**Our ref: HLEF85532 – Cottered Solar Farm**

## **EA Comments Response Technical Note – NE/2024/137757/02 – Land to the west of the A507 between Cottered and Cromer, Hertfordshire, SG9 9PU**

This technical note has been prepared to provide additional information requested by the Environment Agency (EA) in the objection letter dated 18<sup>th</sup> of February 2025 in regards to the installation and operation of a solar farm including co-located energy storage facilities, onsite substation, ancillary infrastructure and landscaping at Land to the West of the A507 Between Cottered and Cromer, Hertfordshire, SG9 9PU. The objections raised by the EA are summarised below.

**Annex A – Level of ground clearance to the lowest leading hedge of the solar panels in mAOD and Cross-Sections (Appendix E of FRA HLEF85532 Updated\_V2)**

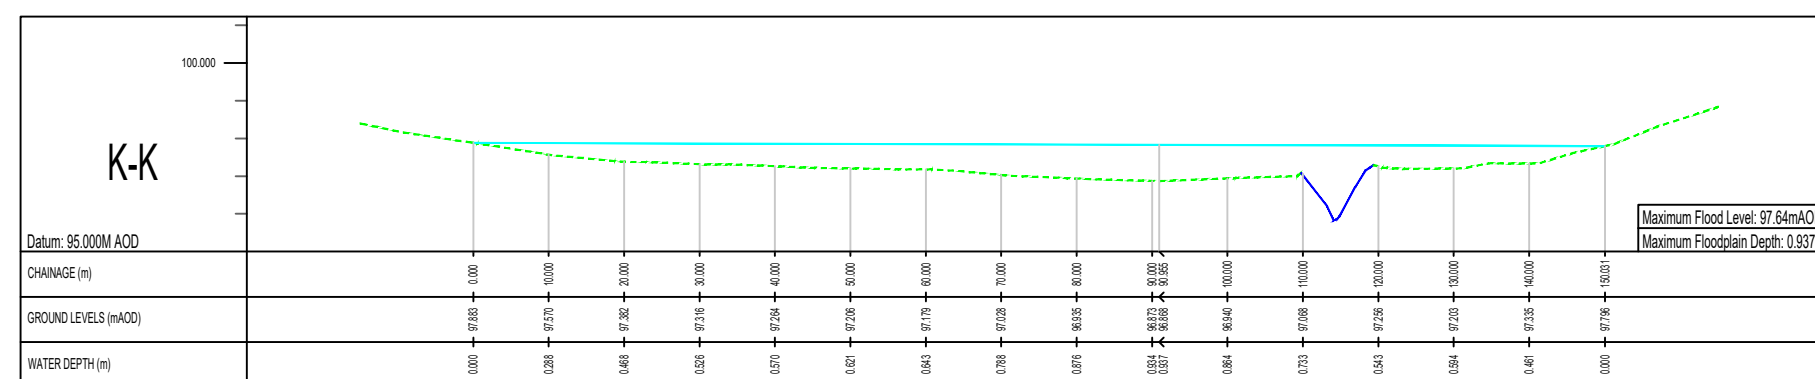
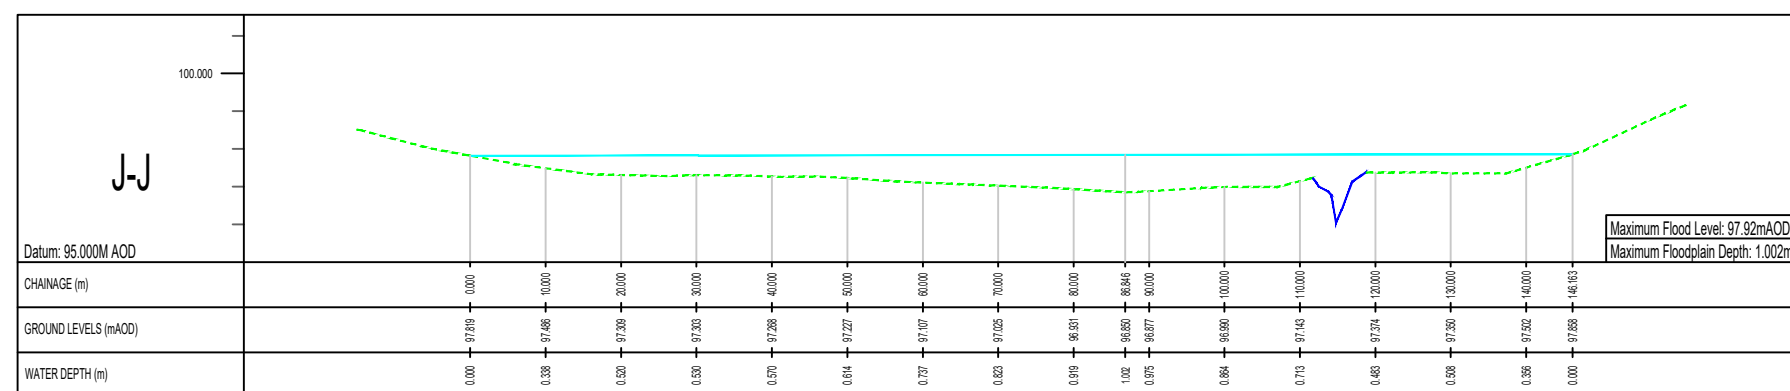
*Discrepancies between the FRA and Appendix E and F*

Appendix E and F have been updated to address the discrepancies highlighted in the EA comments. The updated drawings are available as Annex A and B of this technical note.

- Appendix E indicates the maximum flood depths for each cross section. It has been updated to indicate the level of ground clearance to the lowest leading hedge of the solar panels in mAOD. An updated copy is available as Annex A of this technical note. Appendix F indicates the proposed level of ground clearance for the solar panels at each cross section. This includes a 300mm freeboard. As the flood level varies across the site, it is not proposed that all solar panels will be raised above the maximum flood level within the site. Solar panels will be raised incrementally from west to east following the increase in flood levels. Solar panels located within two cross sections will have ground clearance from the lowest leading hedge to the upper band recommendation (e.g solar panels located within cross sections AA-BB will all be raised to 100.47m AOD).

- Flood levels in mAOD have been included in the cross sections available in Appendix E and labels to the cross sections have been included in the corresponding drawing.
